Re: Railway (Metrolink - Estuary to Charlemont via Dublin Airport) Order [2022]
Metrolink. Estuary through Swords, Dublin Airport, Ballymun, Glasnevin and City Centre to
Charlemont, Co. Dublin

Subject: Application by the National Roads Authority (operating as Transport Infrastructure Ireland) for the Railway (Metrolink–Estuary to Charlemont via Dublin Airport) Order [2022] Case Number: NA29N.314724

RE: SUBMISSION ON THE METROLINK RAILWAY ORDER APPLICATION IN
RELATION TO THE SITE OF A COMMERCIAL DEVELOPMENT AT 2 GRAND
PARADE, RANELAGH, DUBLIN 6.

RAILWAY ORDER
Charlemont Station Observation

Fig 03A Extract from submission drawing ML1-JAI-ARD-ROUT_XX-DR-Y-02090

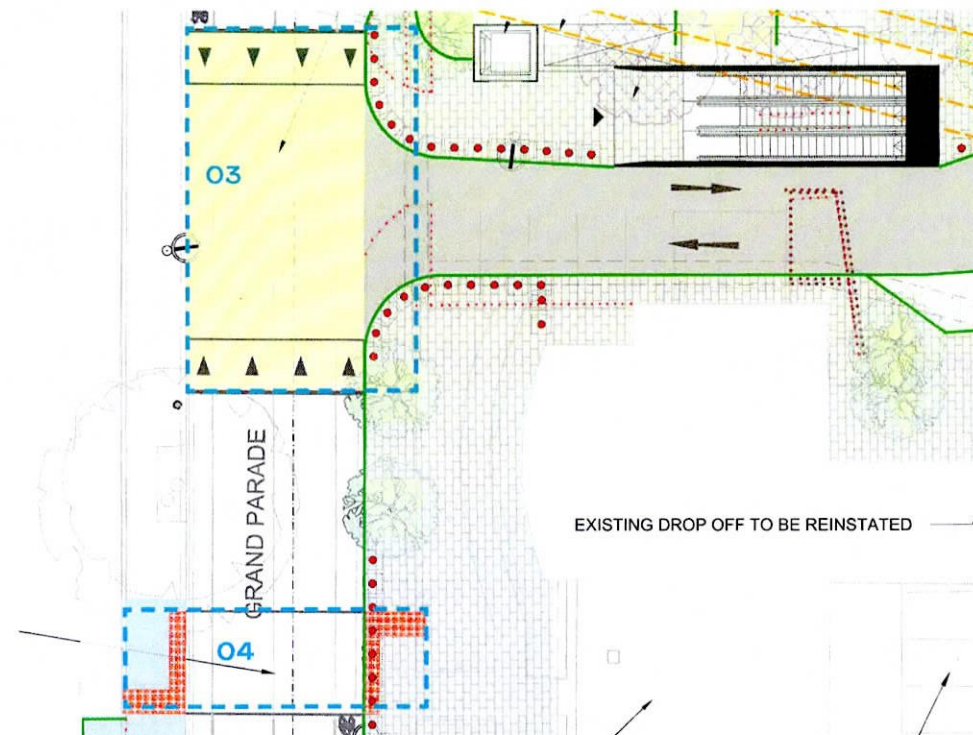
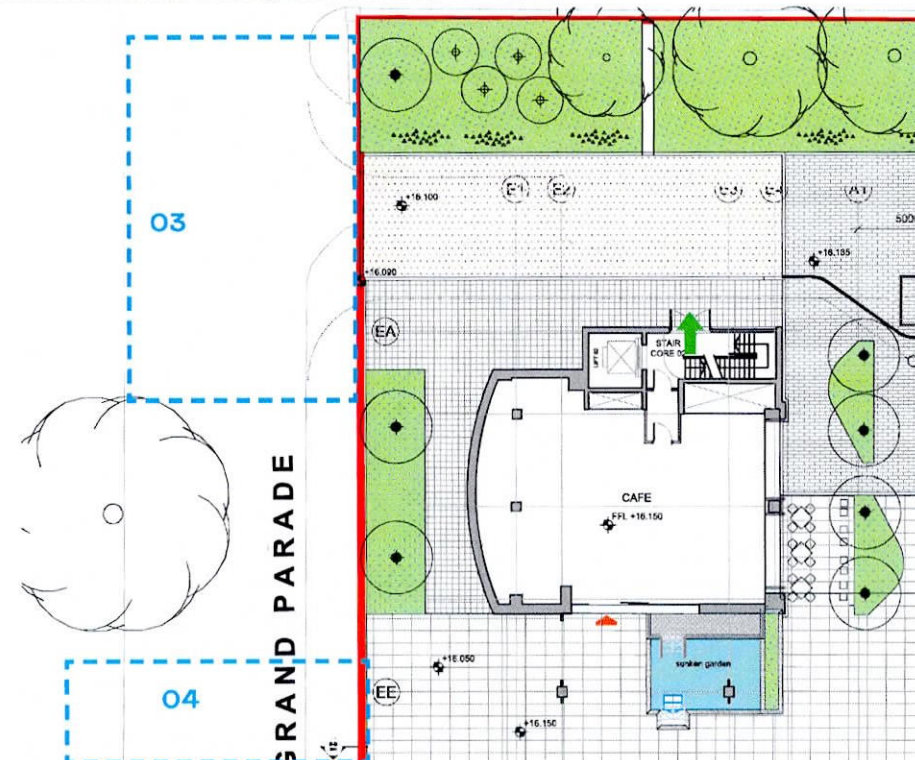
Clarification is sought on the details of these crossing locations and anticipated use/pedestrian flows from each crossing that will direct pedestrians through the 2GP development.

This further detail should be provided prior to the granting of any railway order.

Fig 5A Extract from submission drawing ML1-JAI-ARD-ROUT_XX-DR-Y-02090

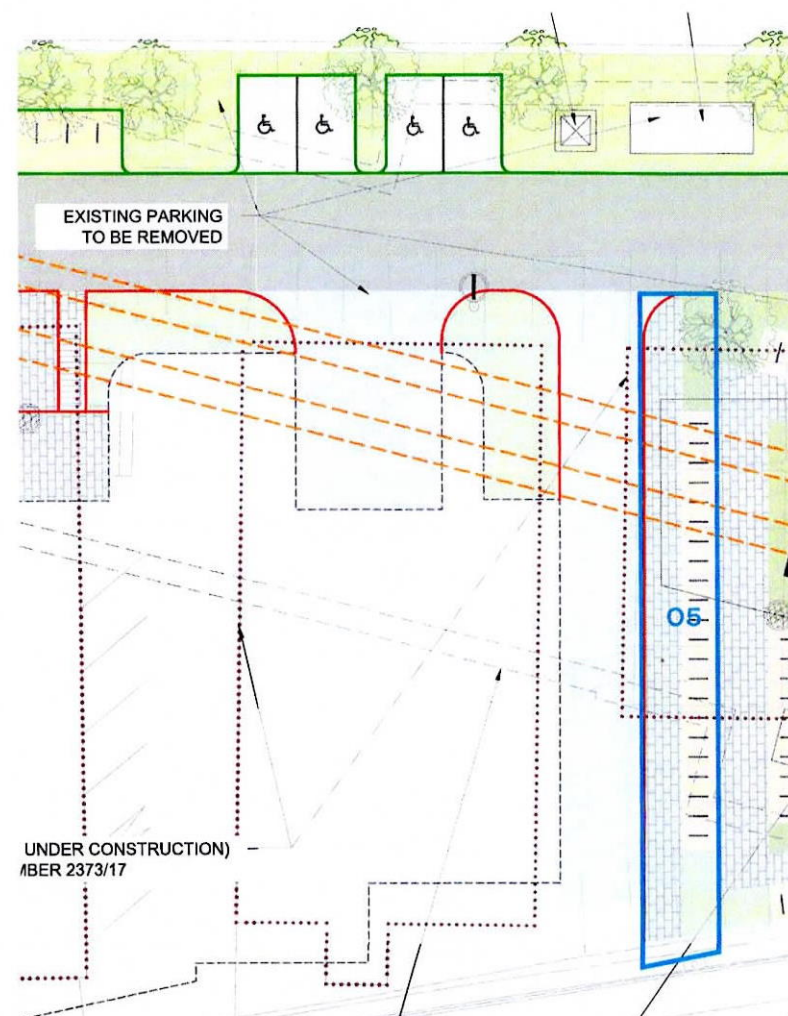
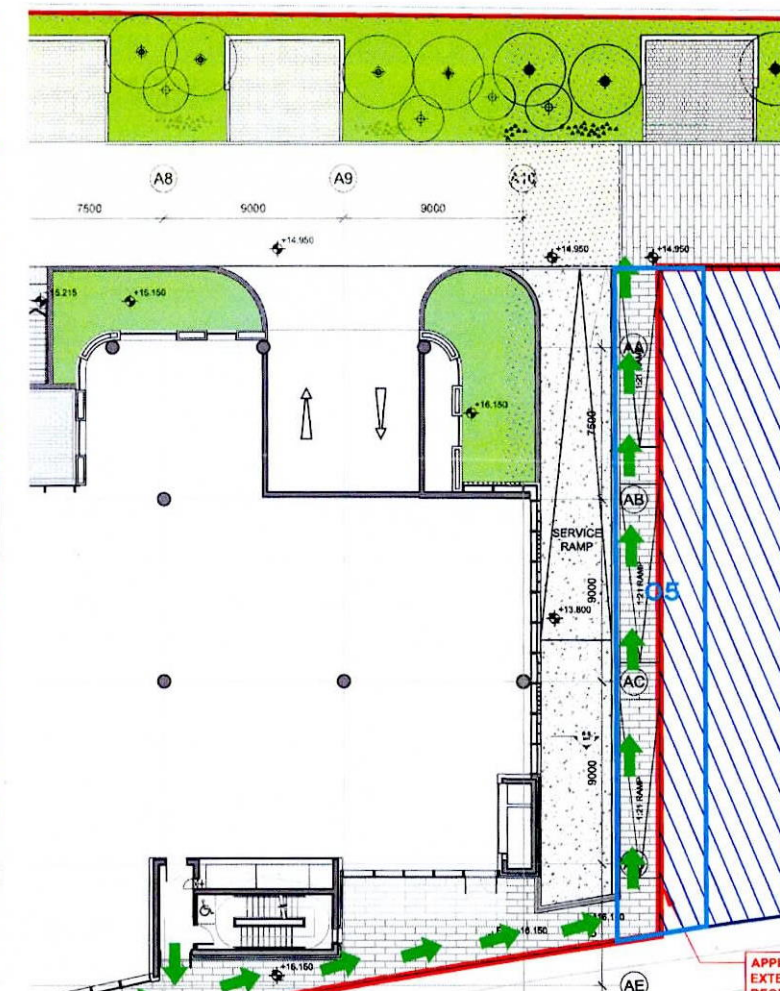
The proposed bicycle parking and associated circulation area to the north of the cycle stands extends into the 2GP development - see Fig 05A and 05B with blue outline,

A clear zone as indicated in Fig. 05B provides a designated fire escape access and egress route which will be compromised by the current bicycle parking configuration and consideration taken to limit access to the cycle stands from the southern side, on this basis, the cycle parking should be reconfigured to avoid impacting on this route.

Fig 06A Extract from submission drawing ML1-JAI-ARD-ROUT_XX-DR-Y-02090

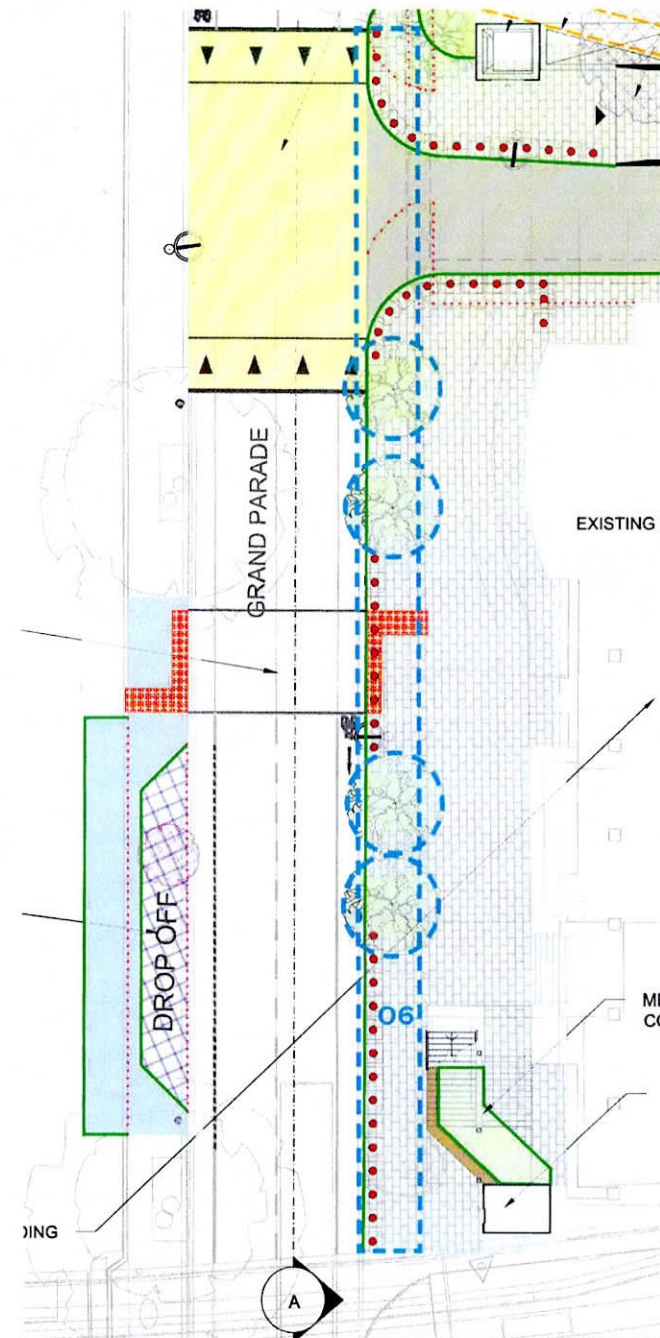
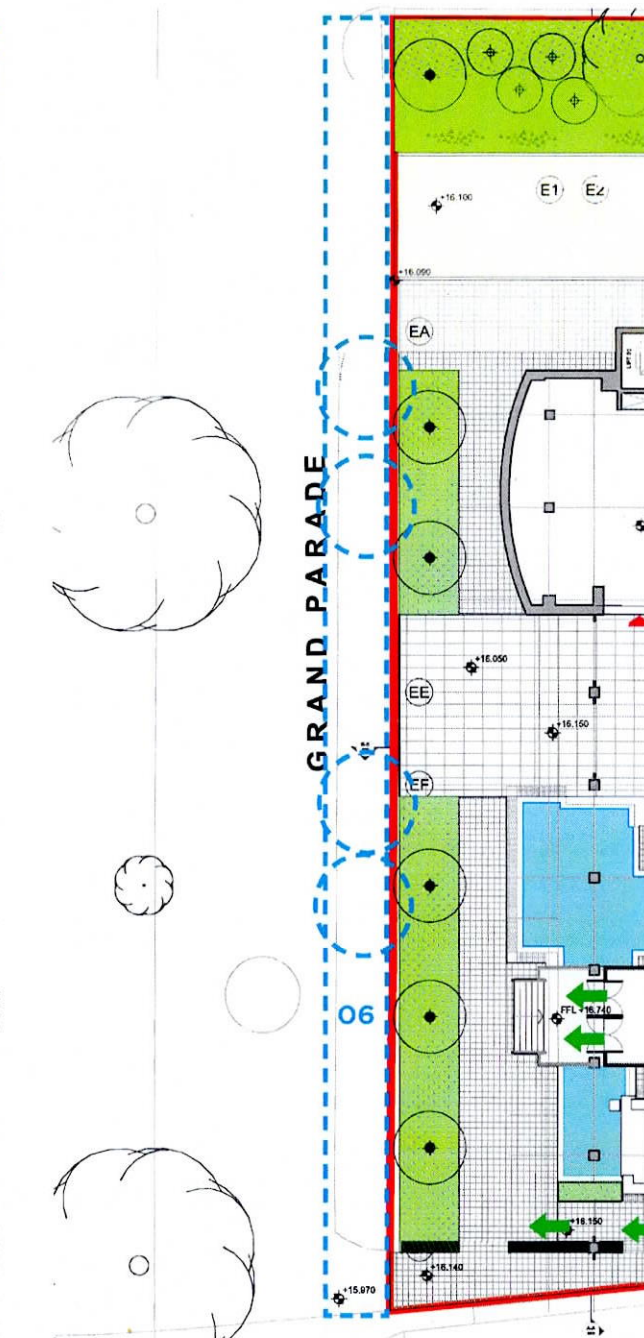
The proposed hard and soft landscaping within the public realm that interface with the 2 Grand Parade (2GP) development will need further consideration to ensure co-ordination between the tree planting and interfaces with the paving finishes and levels and entrance locations to the permitted and under construction 2GP development.

Fig 06A Extract from submission drawing ML1-JAI-ARD-ROUT_XX-DR-Y-02090

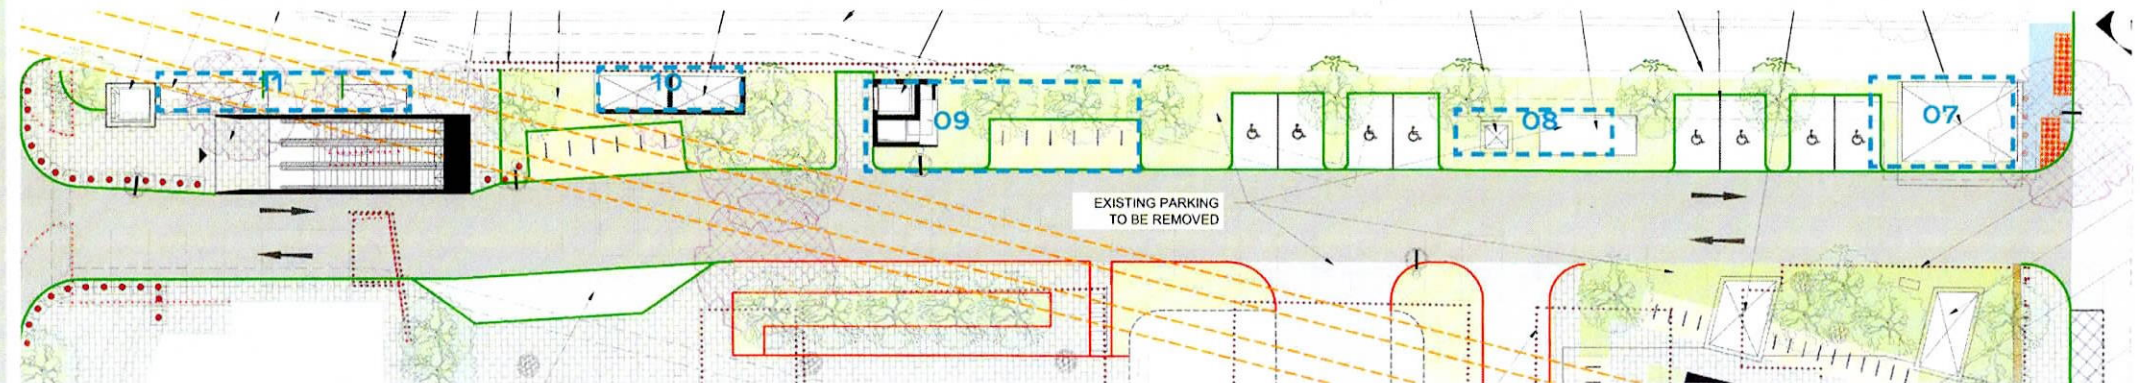
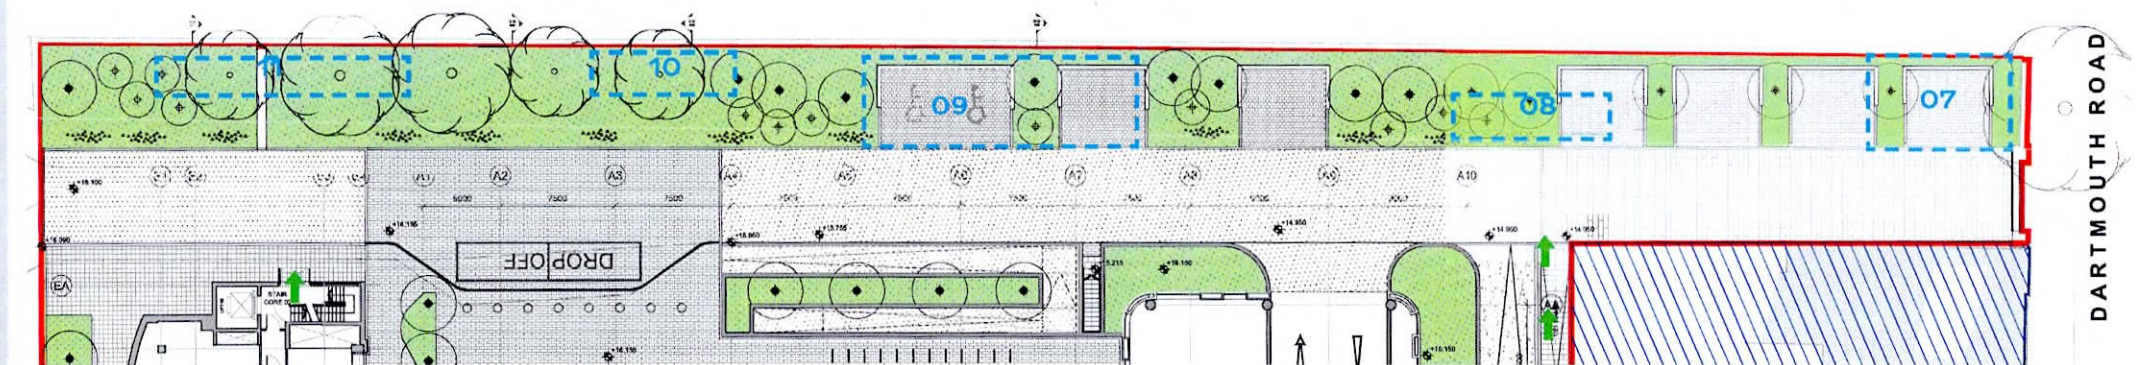
Further design information is sought on the proposed vents, lift shafts and pumping room, with detail to include heights and proposed finishes in order to demonstrate the potential visual impact to the adjacent 2GP development.

Carparking bays, as per the permitted planning, are located in this location. An alternative location for the proposed vents should be considered.

Carparking bays, as per the permitted planning, are located in this location. An alternative location should be considered. Further detail and consideration in these respects should be furnished and included on the application file prior to the granting of any railway order.
